ZEE Systems, Inc.

SERVICE LETTER Z03-035-1

1.0 EFFECTIVITY: Spectrum Electrostatic Sprayers, Inc. Model Z03-035-1, MOD A, Control Unit Serial Number 8641 and lower.

2.0 PURPOSE: The possibility exists in some units that the wire to the 5A circuit breaker may short against the connector. This Service Letter gives instructions to move the wire to prevent this short.

FIG. 2

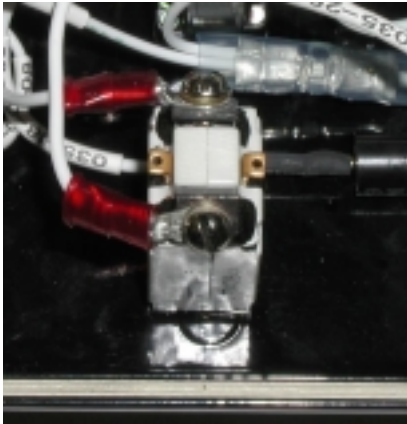
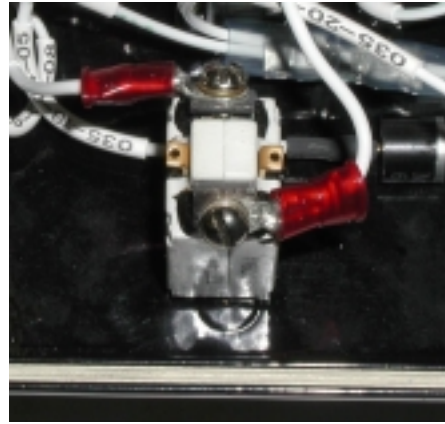
4.4 Disconnect the Z03-036 Cable from the control box. Remove the 4 screws on the top plate and open the Control Box. Take care not to dislodge or damage the rubber gasket in the top plate. If both of the wires that attach to the 5A circuit breaker are on the same side (See FIG.2) the outside wire lug must be relocated.

4.5 Loosen the slotted screw on the outside wire lug. Move the lug so that it attaches on the opposite side of the inside wire lug and away from the connector. See FIG.3. Tighten the slotted screw.
